# **Submission on Riverstone East Draft Precinct Plan on behalf of property owner – 77 Tallawong Road, Rouse Hill**

Prepared by Urban City Planning

16 September 2015

Reference Job 150432

**Figure 3** Proposed Land Zoning Map

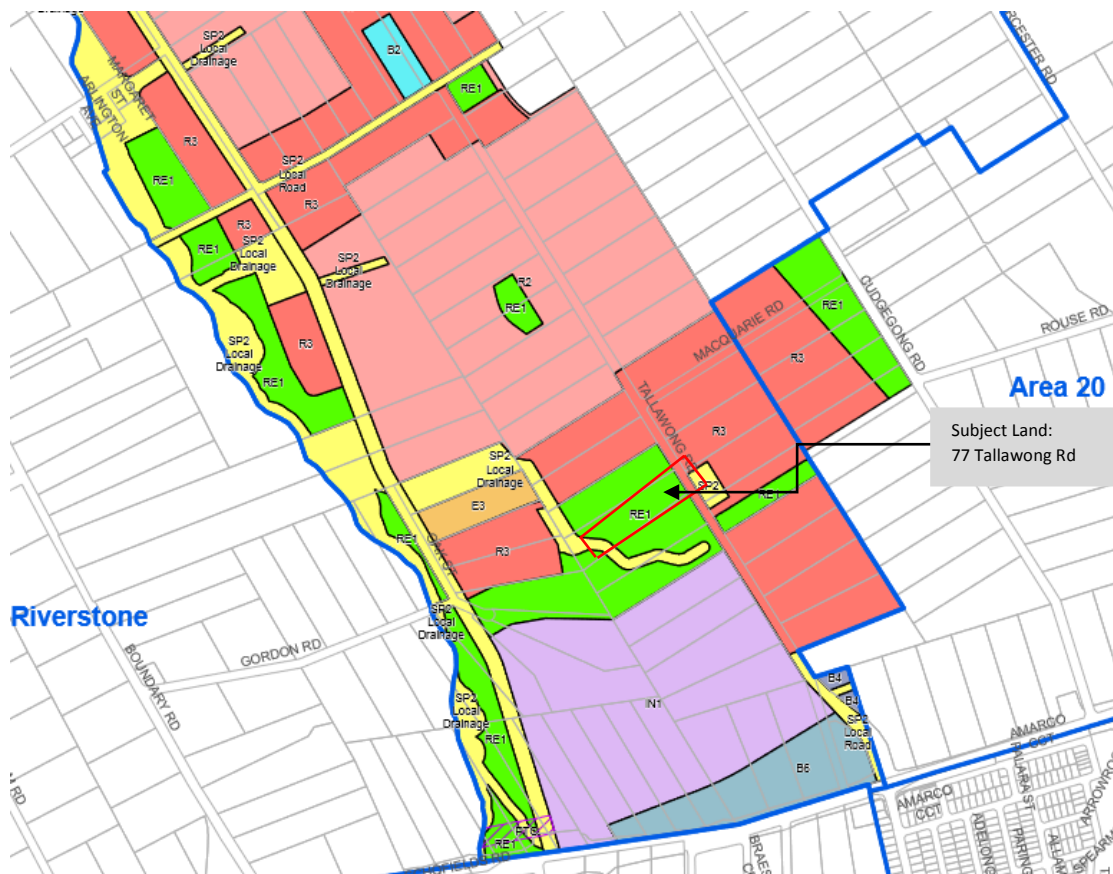
- The majority of the subject land to be rezoned RE1 Public Recreation as illustrated in **Figure 3**.
- A small portion of the subject land to be rezoned SP2 Local Drainage as illustrated in **Figure 3**.

- Notably the proposed RE1 Public Recreation zone also applies to numbers 87, 83 and 67 Tallawong Road to accommodate a double playing field fronting Tallawong Road.

The analysis has shown that a R3 Medium Density Residential zone (permitting low rise apartments) is considered to be more appropriate to replace the proposed RE1 Public Recreation zone on the subject land and that Site 1 (refer to **Figure 18**) offers a strong performing alternative site for sports fields.

**FIGURE 8** Proposed creek reconstruction showing design profile

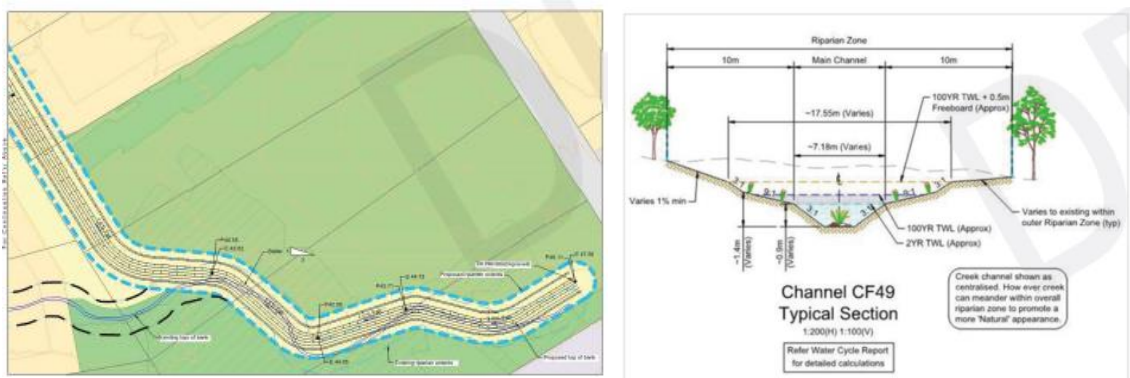
1. The proposed location of the open space link between Oak Street and Tallawong Road and adjoining the stabling yards facility results in poor integration with the surrounding urban structure.
2. The proposed re-construction and channelisation of the southern tributary as Channel CF49 offers limited aesthetic and recreation benefit to the adjoining open space. The proposed channel profile including steep embankment slopes and channel depth have the potential to create a safety hazard for the public who will use the park facilities. - refer **Figure 8**.

3. Risk management measures to be installed and implemented such as fencing may result in poor integration with adjoining open space, reducing the potential multi-use benefits such as would be achieved with a more natural watercourse.
4. The open space network between Oak Street and Cudgegong Road does not provide a suitable link to Second Ponds Creek and the Area 20 Town Centre.
5. The majority of open space proposed is concentrated along the edges of the Precinct, and peripheral relative to residential areas. The majority of residents would be required to cross major roads to access open space including the sub-arterial Clarke Street and the local collector Tallawong Road. With a width of 35m and 20m respectively, these roads would provide a major barrier to pedestrian movement and result in potential safety issues for the future residents - refer **Figures 9 and 10**.

**FIGURE 16** Map illustrating areas within 1km of active open space (in green)

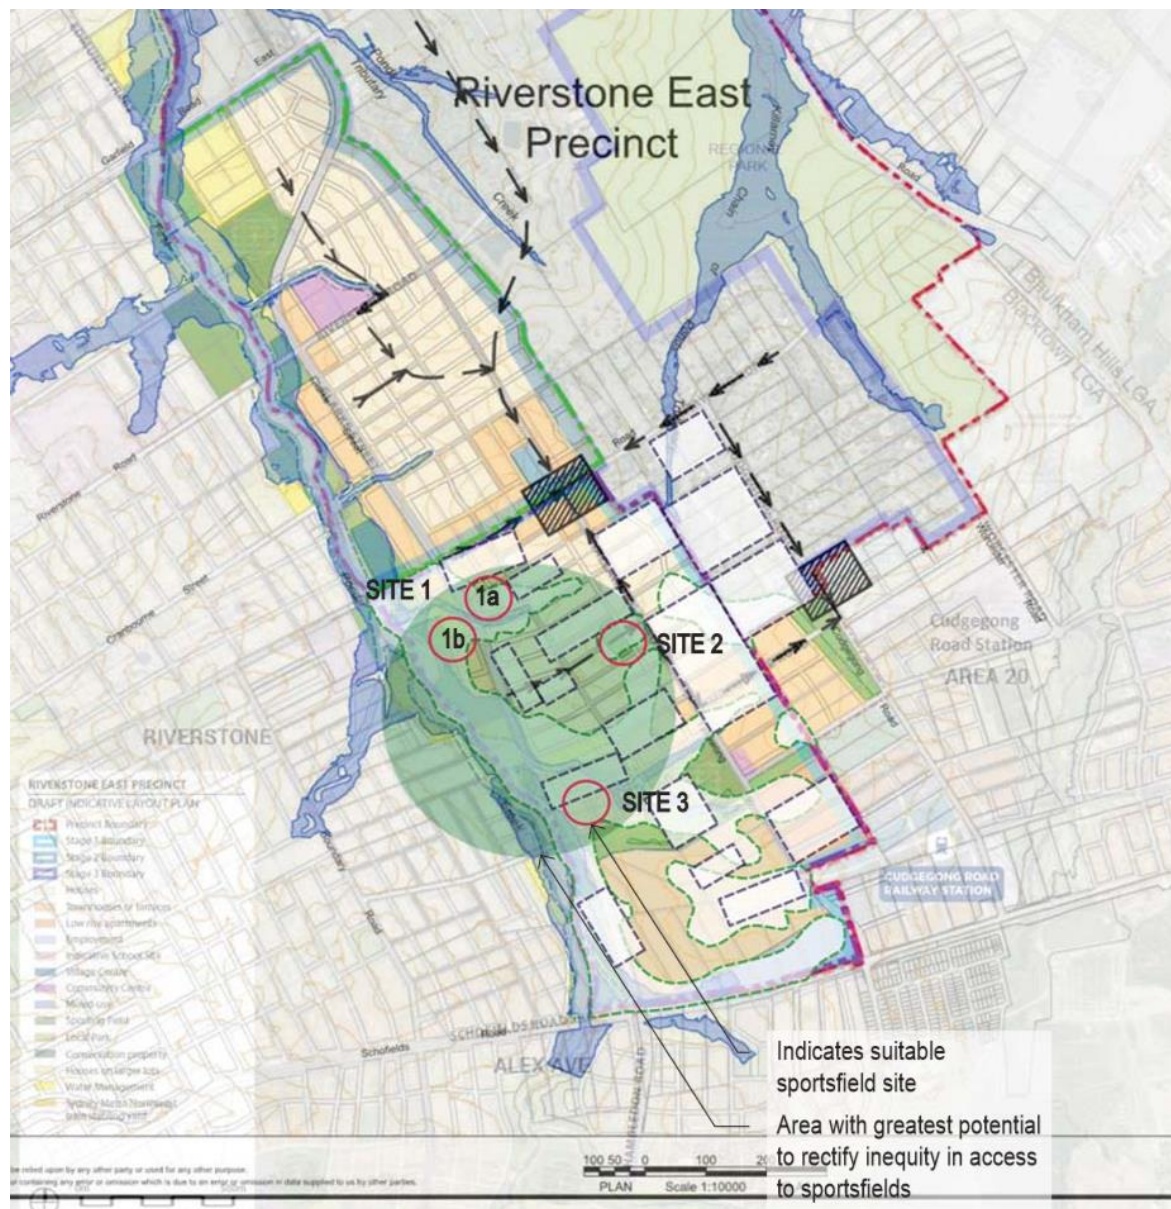
However, the analysis of distribution of sports fields indicates that the vast majority of residents in Area 20 are located within 1km of the sports fields that will be provided between Rouse Road and Second Ponds Creek. Refer to **Figure 16**. Note: for the purposes of developing an alternative open space framework the open space proposed on the subject land has not been included in the distribution mapping.

The analysis has however identified a significant gap in sports fields provision in the eastern part of the Riverstone Precinct. In this area residents are located considerably further than the recommended 1km from local active open space. This represents a major gap in access to sports fields. The Riverstone East Precinct represents an opportunity to address this and restore equity of access to sports fields.

**FIGURE 17** Composite constraints map showing potential sites for sports fields

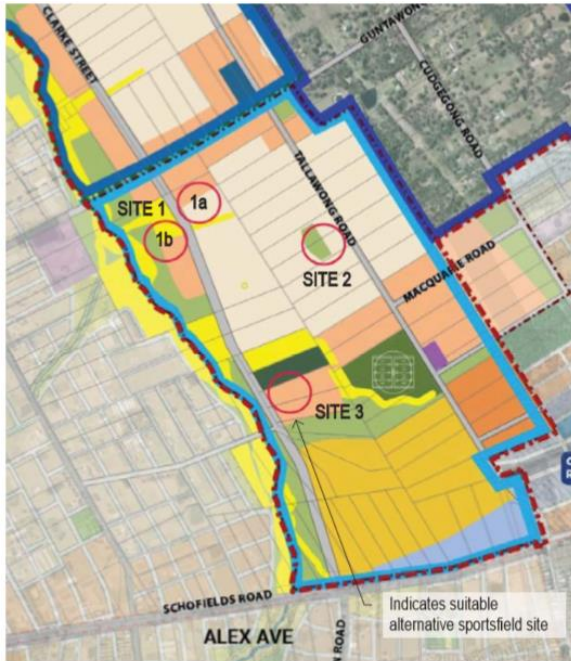
A composite map overlay of the analysis maps (prepared by Clouston Associates, 2015) identifies a number of potential alternative sites for active open space- refer to **Figure 17**. The potential alternative sites have been highlighted because they meet several of the site selection criteria discussed above, including open space planning principles and physical site selection criteria. They also have the potential to compensate for the gap in sports fields provision in the Riverstone Precinct.

**FIGURE 20** Subject land in proximity to future Cudgegong Road Railway Station

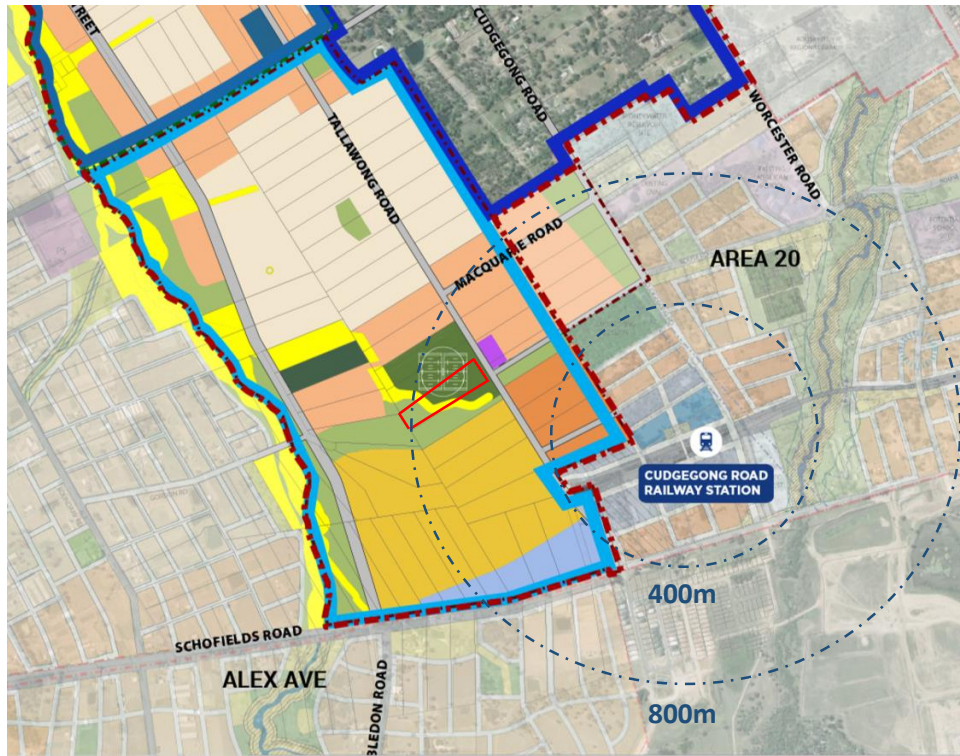
**Figure 20** illustrates that the subject land is within 800m of the future Cudgegong Road Railway Station and is therefore strategically suitable for medium density residential. The amount of high and medium density dwellings should be maximised within 800m of the railway station to concentrate the future population around the railway station. The subject land’s location is prime land for a R3 Medium Density Residential zone.

A better planning approach for the subject land would be to accommodate low rise apartments. This approach would:

1. provide a land use interface that would remove passive surveillance concerns,
2. provide a built form outcome where 3-4 storey apartments would counterbalance the elevated platform created for the stabling yards facility, and
3. maximise use of prime land within 800m of the future Cudgegong Railway Station.
